Application No.: 10/798,292 page -2-

Art Unit 3749

2. Applicant's Premier Objection

SHEET 1 OF 2 replacement sheet

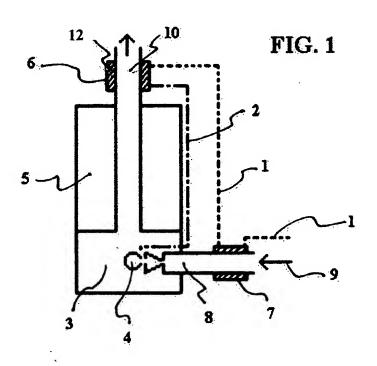
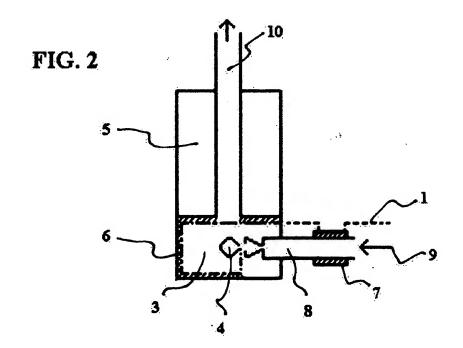
The Examiner objects to the drawings under 37 CFR 1.83 (a), as not showing every feature of the invention specified in the Claims

The Examiner states that the insulating material cited in Claims 28 and 40 is not being shown, when indeed such insulating material, or heat storage material, is indicated in the drawings as the hatch drawn feature surrounding the heat exchanger assembly 6, located at exhaust area 10, as well as the hatch drawn feature surrounding heat exchanger 7 which, as very obvious in the drawing, is located at a heat transfer zone being operated by a source other than the combustion or exhaust

The Examiner is therefore mistaken when objecting to the drawings, because the drawings already conform with 37 CFR 1.83(a). The drawings in fact precisely show the required features of the inventions as referred to in the objected Claims, and no alteration, amendment or addition to the drawings should be required.

Applicant will further include a corrected drawing sheet properly identified.
